Product Change Notification (PCN)

PCN #: 2G-2025

Date: February 23, 2025

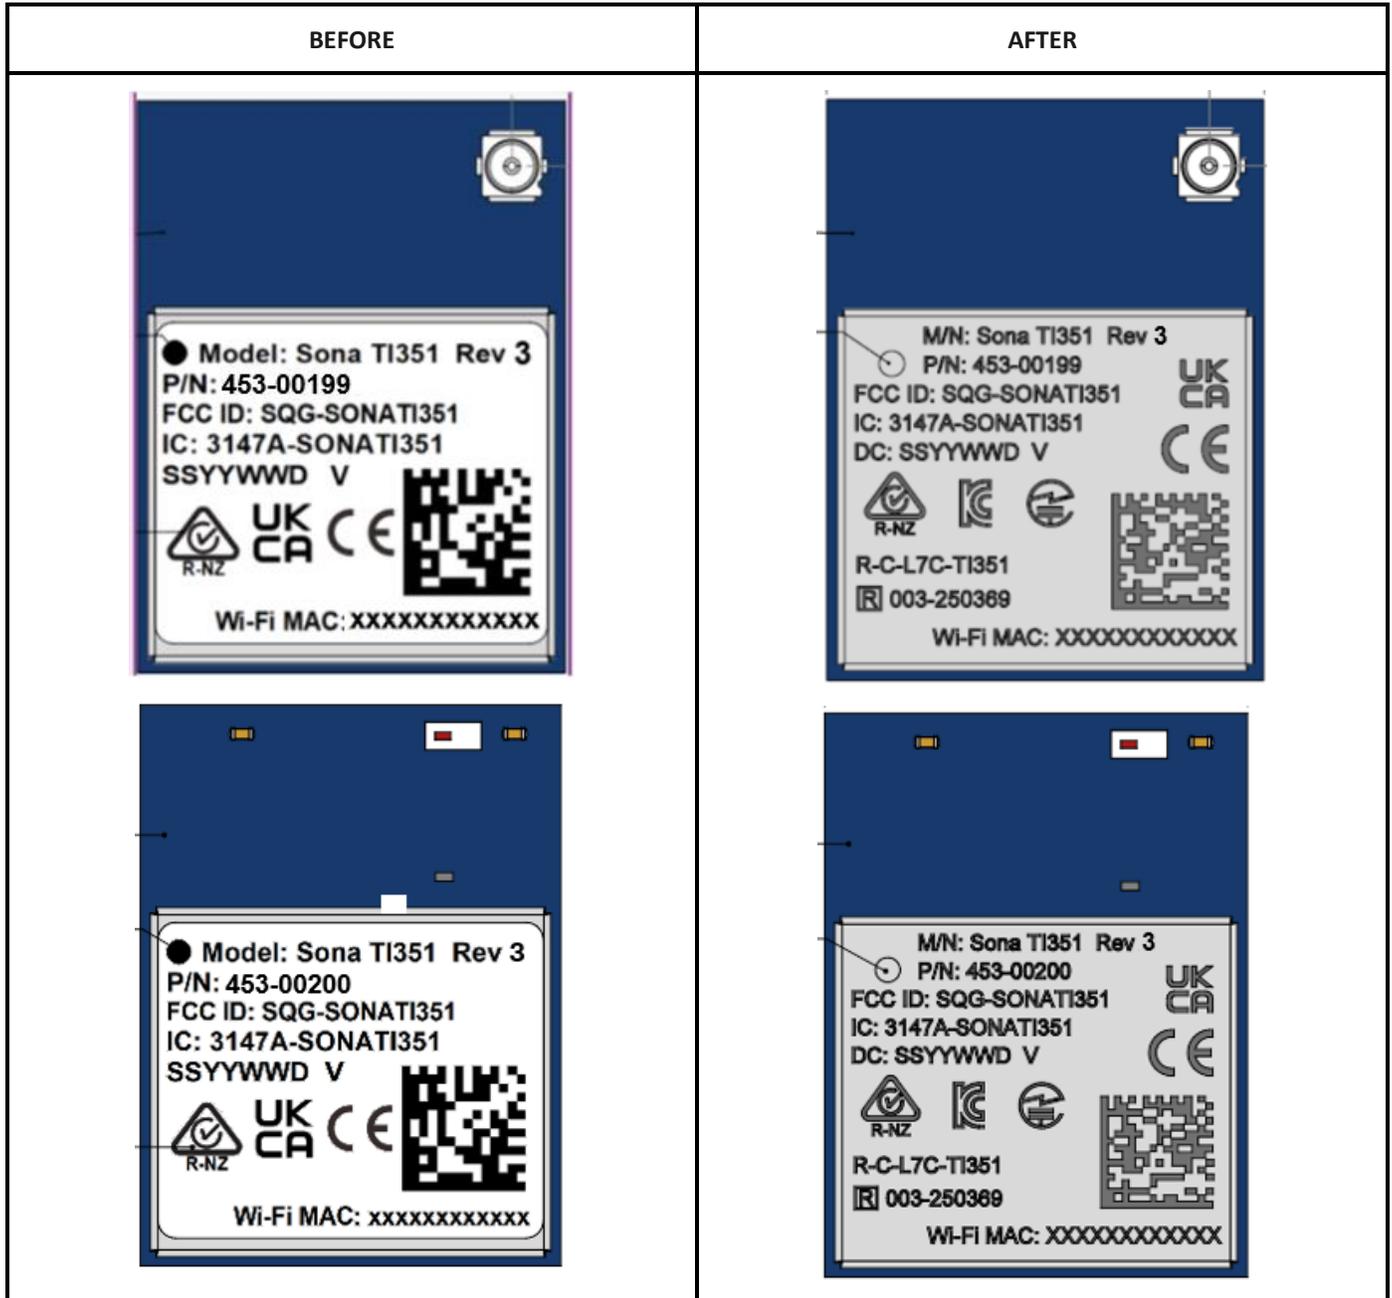
- Update module laser etching to include Japan and Korea certification IDs and logos for Japan and Korea compliance for 453-00199/00200
- Update printed labels to include Japan and Korea certification ID and logo for Japan and Korea compliance for 453-00209

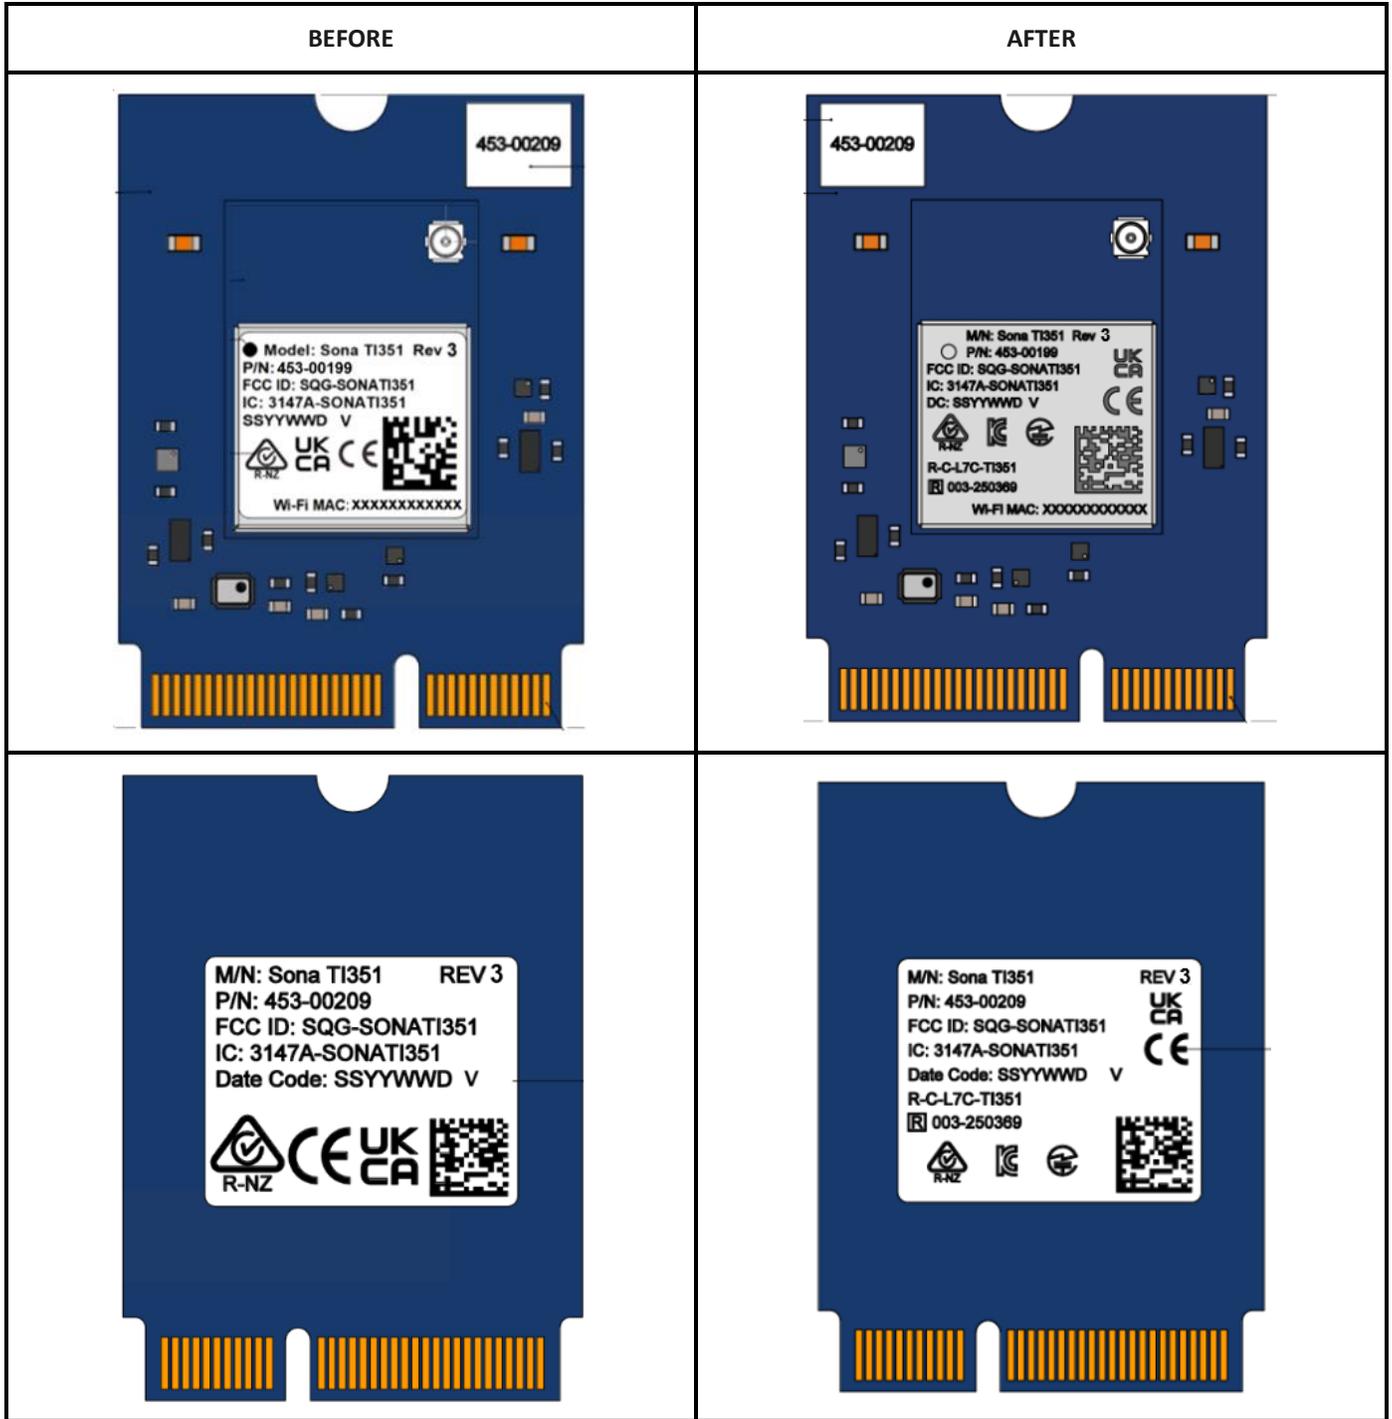
- **453-00199R/453-00199C/453-00200R/453-00200C**
 - On the module laser-etching, add the MIC logo and ID 003-250369 and KC logo and ID R-C-L7C-TI351. The module's revision will remain unchanged.

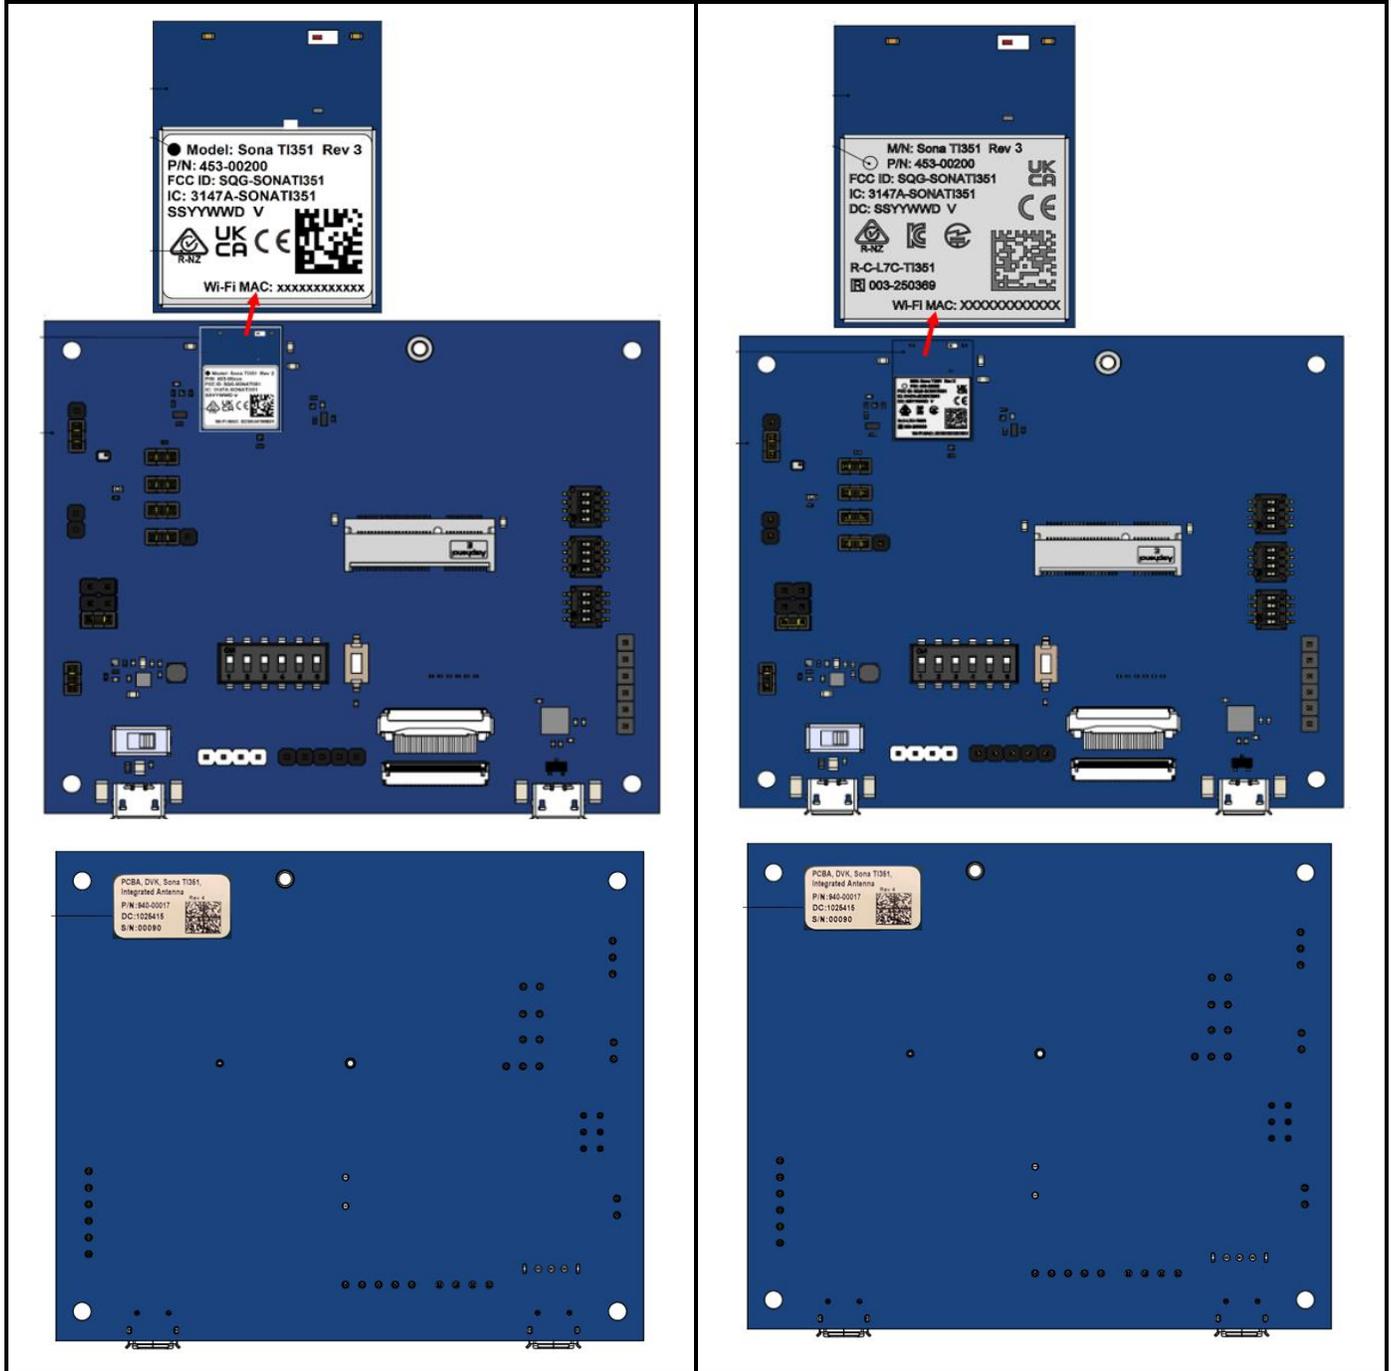
- **453-00209**
 - On the M.2 2230 back product label, add the MIC logo and ID 003-250369 and KC logo and ID R-C-L7C-TI351. The M.2 2230's revision will remain unchanged.
